RE: 10 CFR 71.95(a)(3) report for CoC number USA/9187/B(U)-96

QSA Global, Inc. is making a report under 10 CFR 71.95(a)(3) concerning the Model 865 Type B packages (CoC 9187).

SOURCE ACTUATOR ASSEMBLY

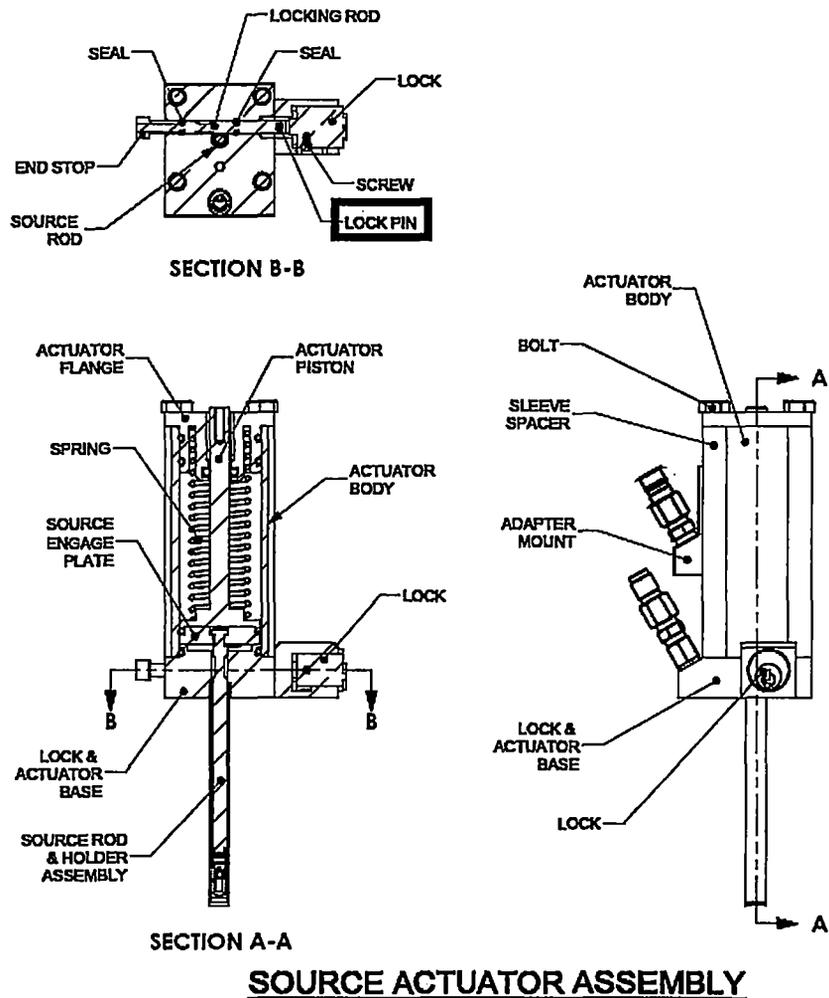
The exploded view of the actuator assembly shown on sheet 4 of drawing R86590 Revision J does not show the pin connecting the plunger lock to the locking rod. The pin has always been present in all Model 865 transport packages and all Model 865 Type-B test specimens. The pin is needed to unlock the source from the shield, but is NOT needed to lock the source into the fully shielded position in the package. See figure below for pin location:

The pin material is 300 series stainless steel and is fully compatible with all adjacent component materials. The presence or absence of the lock connecting pin does not adversely affect the safety and integrity of the Model 865 transport package and does not create a substantial safety hazard under 10 CFR Part 21.
